REV. 2  
 ISO. NO.: MCFI-IND 9  
 BUILDING: A&X.  
 DUKE PIPING CLASS: B  
 SYSTEM SYMBOL: ND-RESID. HEAT REM.  
 PIPING SPEC.: ND-03 P.S. 401.2  
 DRAWING NO.: MC-1414-04.41-00101  
 PROJECT: MCGUIRE

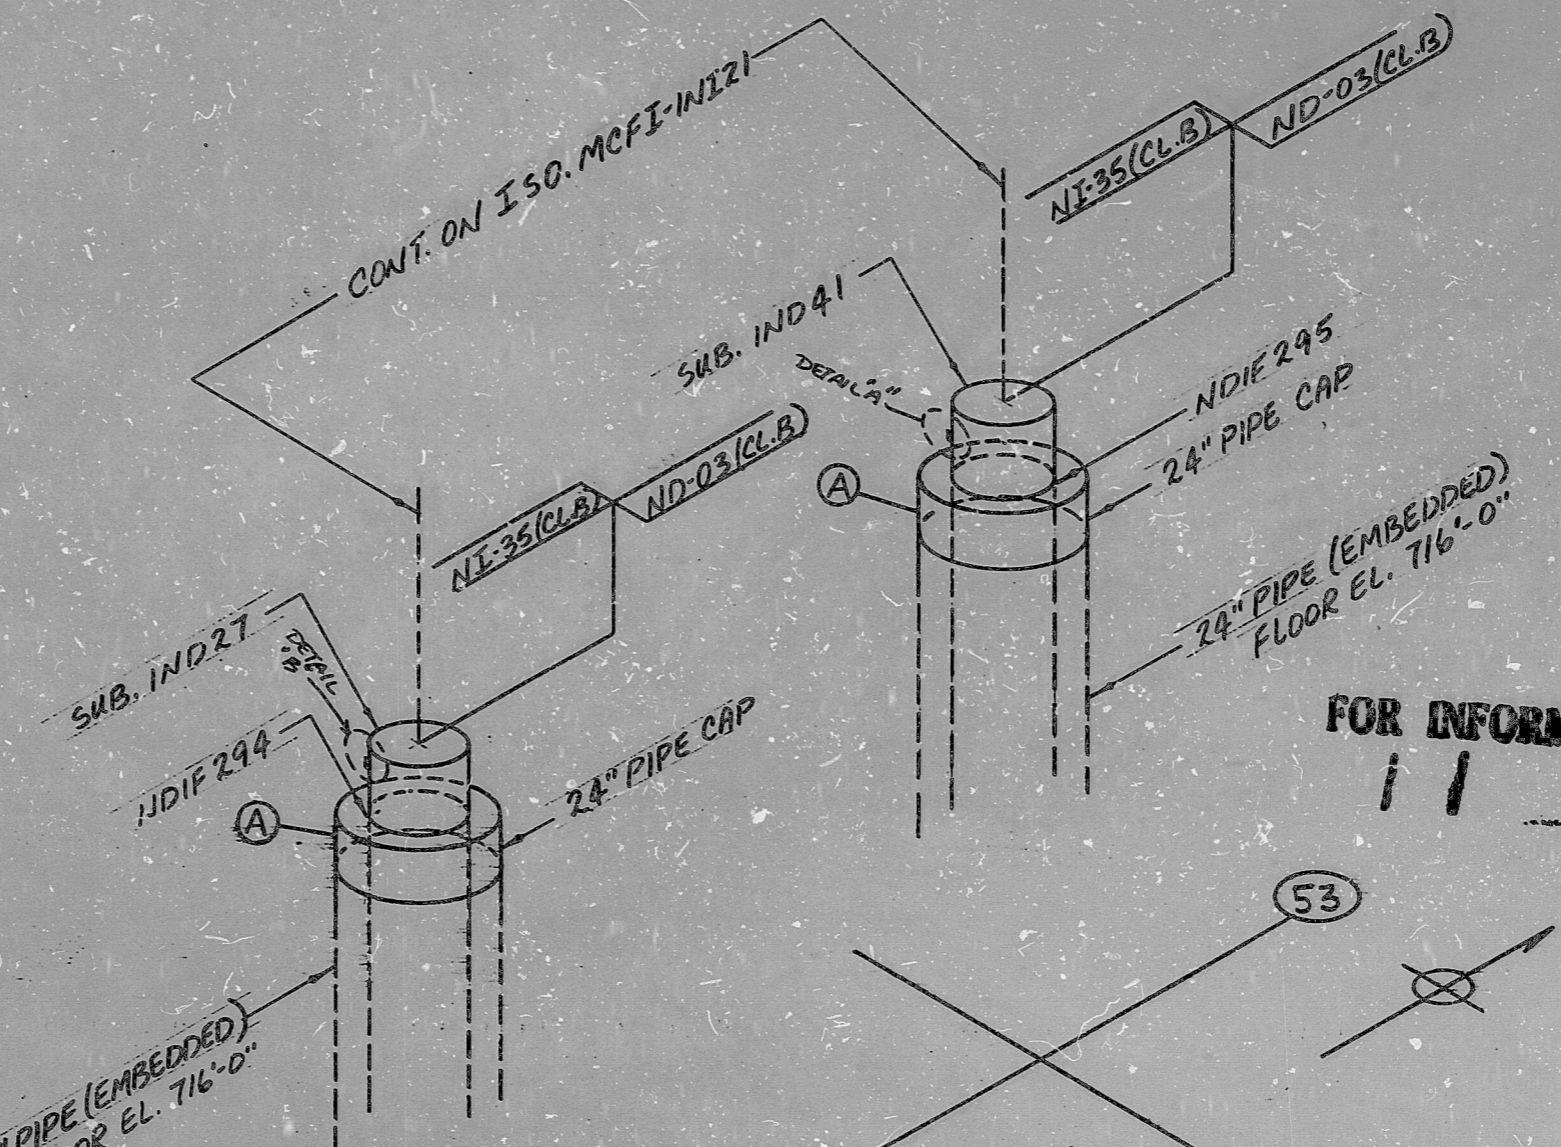
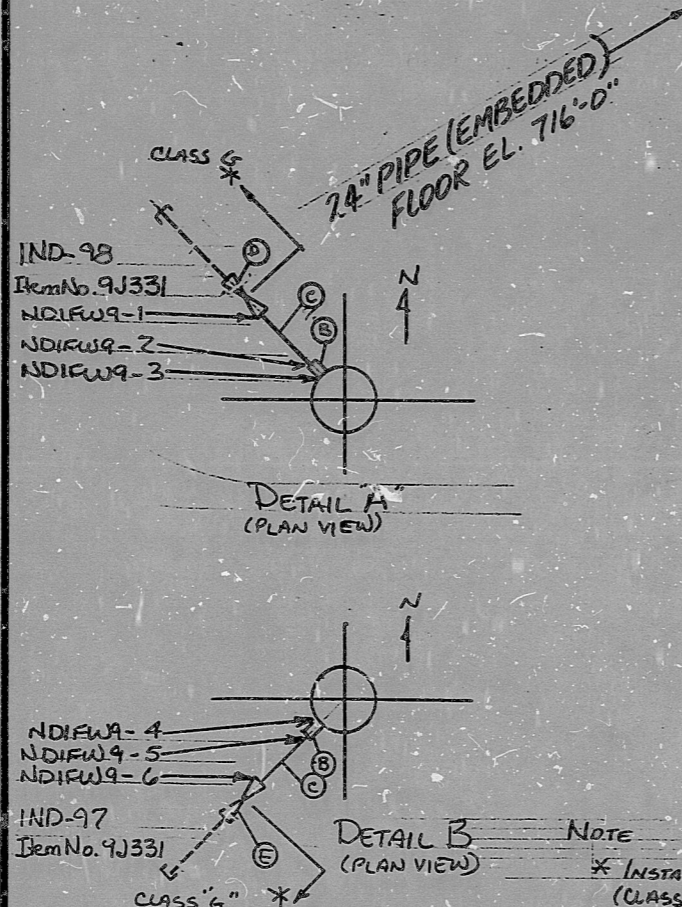
NO.	REVISION
2.	ADDED DETAILS A&B, WELOS NDIFW9-1 thru 6, MAR'L S.D.E., ADDED QA 1
1.	REVISED PIPE CAP TO CS (P-1)
0.	RELEASED FOR CONSTRUCTION
